January 4, 2007

**ADDENDUM NO. 1
TO
THE PLANS AND SPECIFICATIONS
FOR
SENTER ROAD WIDENING PROJECT – PHASE II
(TULLY ROAD TO SINGLETON ROAD)**

ADDENDUM NO.1
EXISTING CONDITIONS AND DEMOLITION PLAN SHEET 8
ATTACHMENT NO.1

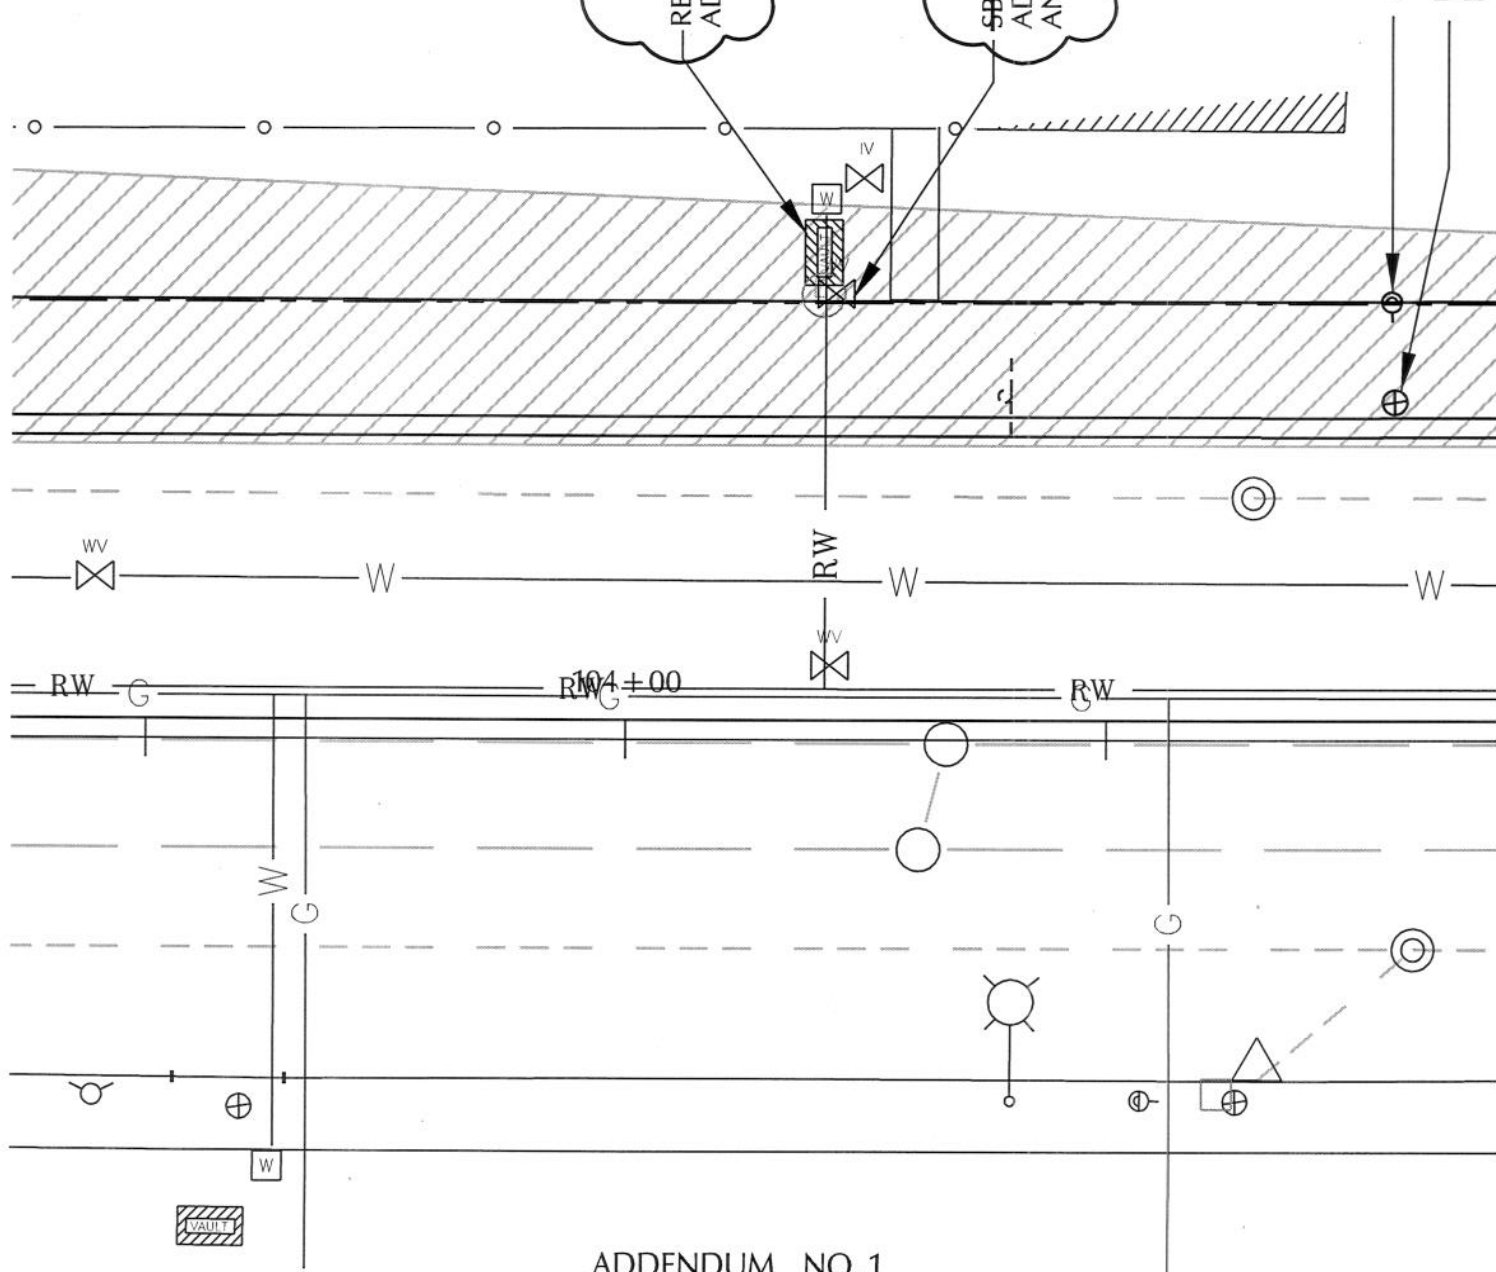
- Item 1 **REVISE** plan on Sheet No. 8, STA 103+78.00, 46' RT., to read the note as follows: “RELOCATE AND ADJUST WATER VALVE & ELECTRICAL ANODE TO GRADE.” (See Attachment No.1)
- Item 2 **REVISE** plan on Sheet No. 8, STA 103+78.00, 50' RT., to read the note as follows: “RECYCLED WATER METER VAULT TO BE ADJUSTED TO GRADE.” (See Attachment No.1)

—RECYCLED WATER METER VAULT TO BE
ADJUSTED TO GRADE ~~BY SBWR~~.

~~SPWR TO~~ RELOCATE AND
ADJUST WATER VALVE & ELECTRICAL
ANODE TO GRADE
